days for a delayed response. Applicants respectfully submit that the PTO's calculation of Applicant Delay contains an error and that the correct Applicant Delay is 82 days, as outlined further below.

NOTICE OF ALLOWANCE AND FEE(S) DUE

APPLICATION NO.	FILING DATE	FIRST NAMED INVENTOR	ATTORNEY DOCKET NO.	CONFIRMATION NO.
10/063,288	04/08/2002	Claes Wallen	19497-011001 / P16488US00	2442
TITLE OF INVENTION: DEVICE AND METHOD FOR MIXING MEDICAL FLUIDS

**DETAILED ACTION**

FIG. 6.

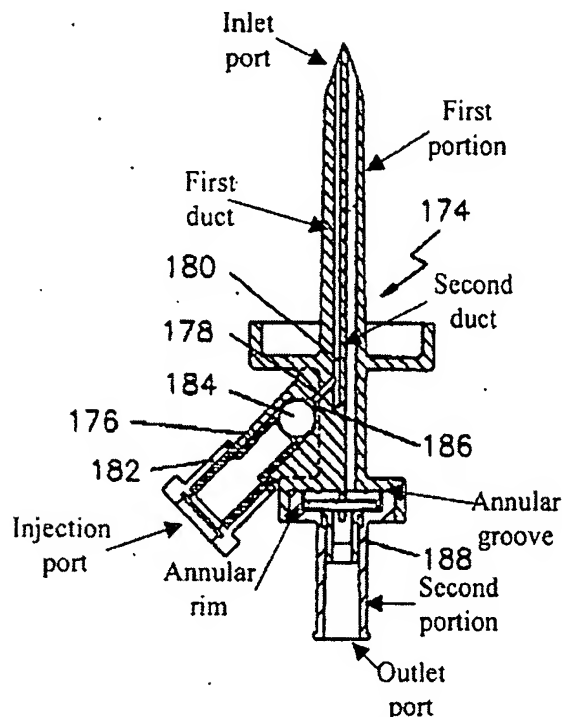
In the specification and figures, Richmond discloses the device as claimed by applicant. With regard to claims 1 and 9, Richmond discloses a device that is capable of mixing medical fluids comprising ports that may be used as an inlet port, injection port, and outlet port, respectively (see drawing, as annotated by Examiner, below, FIG 6). The device comprises a first duct 180 that extends between the inlet port and the injection port, and a second duct that extends between the inlet port and the outlet port (see FIG 6). The injection port comprises a hydrophobic, or fluid-proof membrane 182 that is capable of being penetrated by another device (see column 6, lines 18-53). The

and a second portion that houses the outlet port. Richmond illustrates that the portions are separate through the use of diagonal lines, indicating that the portions may be made of different materials.

differentiate the claimed apparatus from a prior art apparatus satisfying the claimed structural limitations. See MPEP 2114. In the instant case, applicant has failed to set forth any structural limitations that define the claimed connection. The Richmond device appears to have a friction fit between the first and second portions, which may snap into place. Absent any defining structural characteristics, the Richmond device is capable of operating as claimed by applicant, meeting the limitations of the claim.

**FIG. 6.**

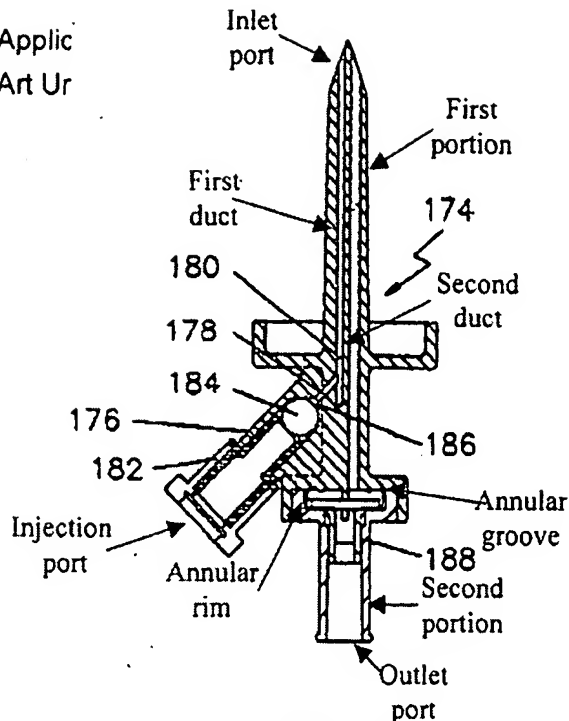
In the specification and figures, Richmond discloses the device as claimed by applicant. With regard to claims 1 and 9, Richmond discloses a device that is capable of mixing medical fluids comprising ports that may be used as an inlet port, injection port, and outlet port, respectively (see drawing, as annotated by Examiner, below, FIG 6). The device comprises a first duct 180 that extends between the inlet port and the injection port, and a second duct that extends between the inlet port and the outlet port (see FIG 6). The injection port comprises a hydrophobic, or fluid-proof membrane 182 that is capable of being penetrated by another device (see column 6, lines 18-53). The device further comprises a first portion that houses the inlet port and the injection port and a second portion that houses the outlet port. Richmond illustrates that the portions are separate through the use of diagonal lines, indicating that the portions may be made of different materials.

With regard to applicant's recitation of the type of connection between the first and second portions, such a statement is held by the examiner to be a statement of the function of the device. It has been held that a recitation with respect to the manner in which a claimed apparatus is intended to be employed does not differentiate the claimed apparatus from a prior art apparatus satisfying the claimed structural limitations. See

connector. Examiner is using that particular figure of the Richmond device to show that the pieces are separate, providing the possibility that they may be formed of different materials, as taught by Wood.

FIG. 6.

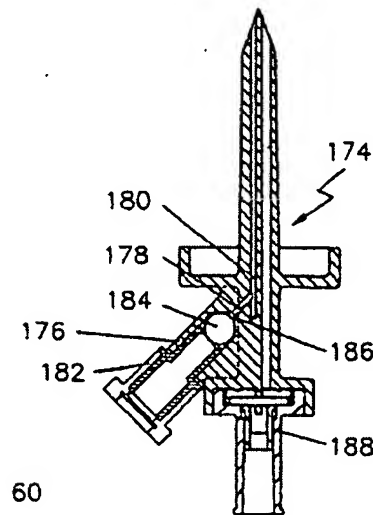
(*Richmond '630, column 6, lines 38-52*) FIG. 6 shows a spike 174 which is a vented spike, i.e., the spike 174 has a gas tube 176 defining a gas passageway 178, and the gas passageway 178 is in fluid communication with a first fluid passageway 180 of the spike 174.

Preferably, a hydrophobic membrane 182 is positioned athwart the gas passageway 178, and a ball 184 is positioned for reciprocating movement within the gas passageway 178. The ball 184 can contact a seat 186 that is formed in the gas tube 176 to block fluid flow through the gas passageway 178. On the other hand, gas within the fluid passageway 180 will urge the ball 184 away from the seat 186 to permit the gas to pass out of the fluid passageway 180 through the gas passageway 178 and hydrophobic membrane 182. The spike 174 also has a female luer fitting with valve 188.

The other port has a first luer fitting portion with a valve to permit fluid flow through the spike when a corresponding second luer fitting portion is engaged to the first luer fitting portion and to prevent fluid flow through the spike when the second luer fitting portion is not connected to the first.
